Proposed Revisions to a Standard Plans Index

Index Number: 102-660

Index Title: Sidewalk Closure

PEDESTRIAN DIVERSION - OPTION 2
 (Work Zone Speed 35 mph or Less)

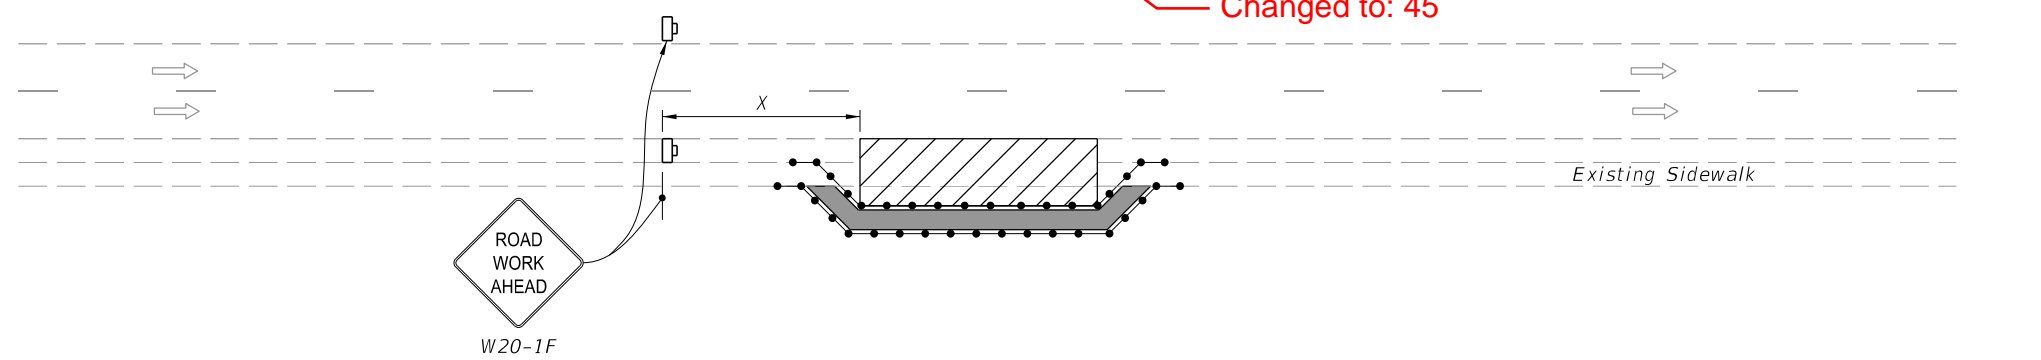
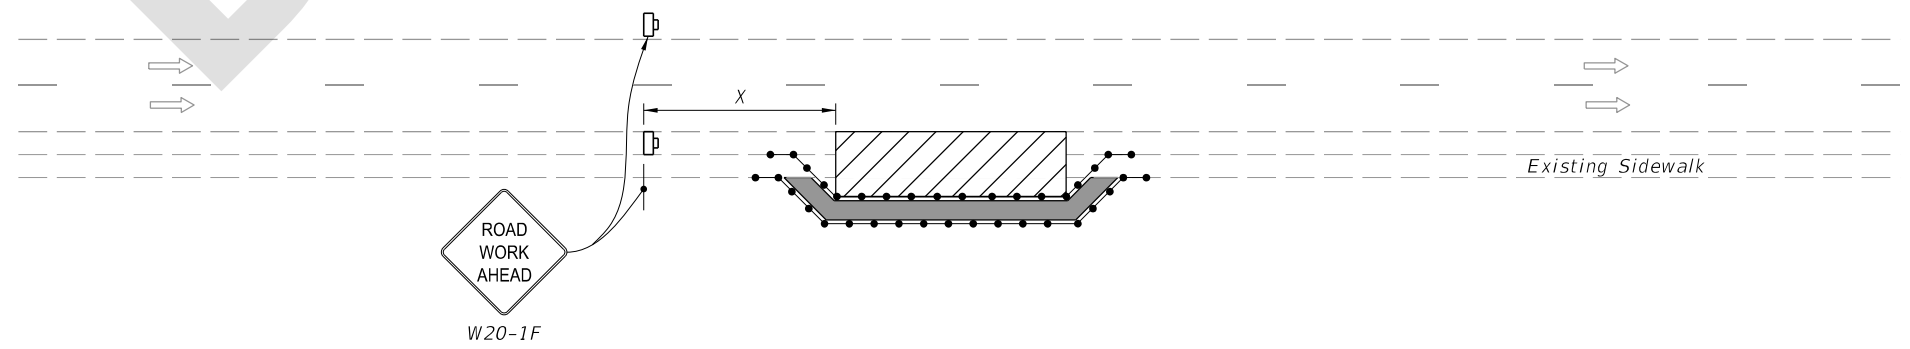
Increase the maximum work zone speed allowed for option 2 to 45mph.

With the work zone speed capped at 35mph, it creates a gap in the applicability of option 2. There have been work zones that needed to use option 2 because they could not meet the length of need requirements for option 1 but the speed limit was greater than 35mph. This makes using a lane closure for pedestrian accommodations difficult in these areas.

Changed to: 45

PEDESTRIAN DIVERSION - OPTION 2
(Work Zone Speed 45 mph or Less)
